## QUALITY ASSURANCE -- NON-CONFORMANCE REPORT

**Report No:** NCR-000663

**Reference Description:** Base Metal Repair (Buttering) without Engineer's Approval, SA3-438 Longitudinal Stiffener Splice Plate, North Tower Lift 2-3

**Dear:** Mr. Charles Kanapicki  
**Job Name:** SAS Superstructure

**Reference Description:** Base Metal Repair (buttering) without the Engineer's Approval, Longitudinal Splice Plate SA3-433

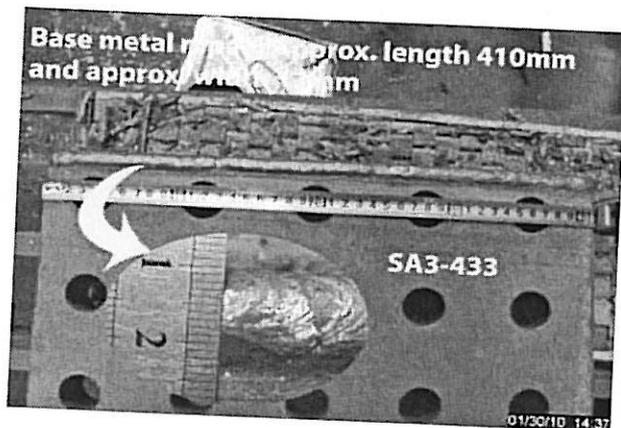
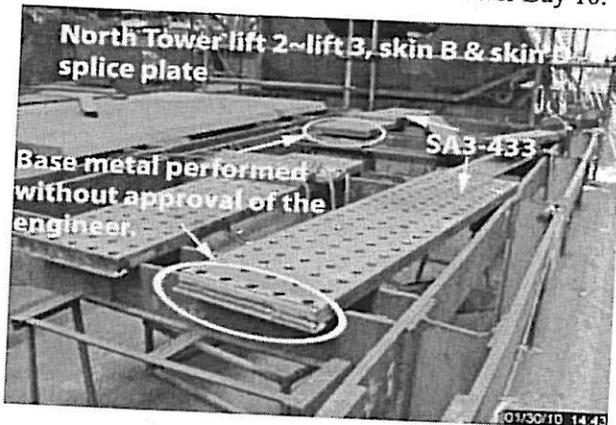
During random in-process observations of the fabrication of North Tower lift 2 ~ lift 3, skin B & skin D splice plates, Caltrans Quality Assurance (QA) observed the following issues:

- ZPMC performed deposition of weld metal (buttering/build up) by Shielded Metal Arc Welding (SMAW) process on the base metal edge of splice plates for skin B and skin D of North Tower lift 2 ~ lift 3.
- This base metal repair was performed without the approval of the Engineer.
- This build up was performed across the entire width of the edge and measured approximately 12mm thick and approximately 410mm in length.
- The material thickness is 50mm.
- The members are both identified as SA3-433.
- The plate material is designated as A709 grade 485 Non-Seismic Performance Critical Members (Non-SPCM).
- These members are located inside of Tower Bay 10.

**Reference Description:** Base Metal Repair (Buttering) without Engineer's Approval, SA3-438 Longitudinal Stiffener Splice Plate, North Tower Lift 2-3

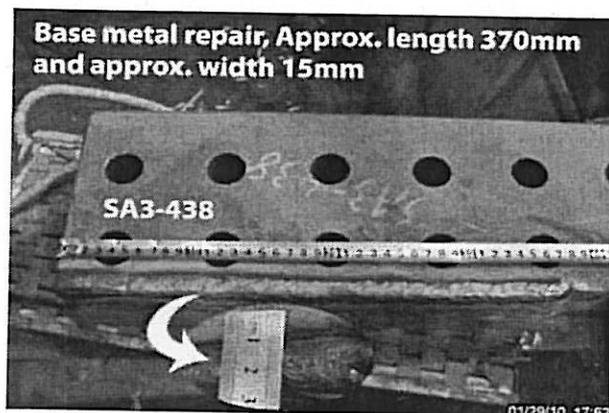
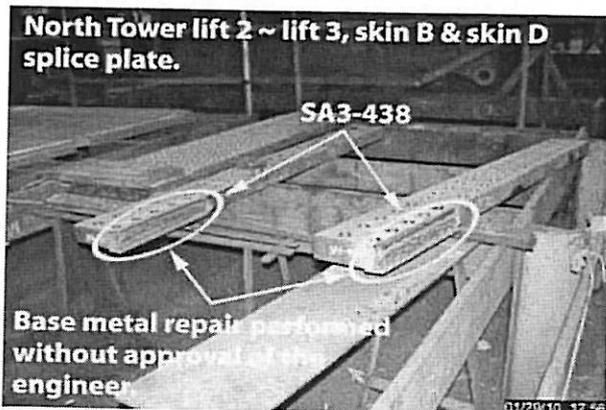
During random in-process visual inspection of North Tower lift 2 ~ lift 3, skin B & skin D splice plate, Caltrans Quality Assurance (QA) discovered the following:

- The deposition of weld metal (buttering/build-up) by Shielded Metal Arc Welding (SMAW) process on the base metal of SA3-438 splice plates.
- This build-up is measured to be approximately 15mm in width and approximately 370mm long.
- The plate thickness is 60mm.
- The material grade is A709M HPS 485 T2-Z, non-SPCM.
- This base metal repair was performed without the Engineer's approval.
- The welder is identified as 066236.
- The members are located in Bay 10.

The maximum build up limits for weld joint correction from AWS D1.5 Section 3.3.4.1 (the lesser of 20mm or 2t) was applied to these elements, which makes the work performed in conformance to the contract specifications.
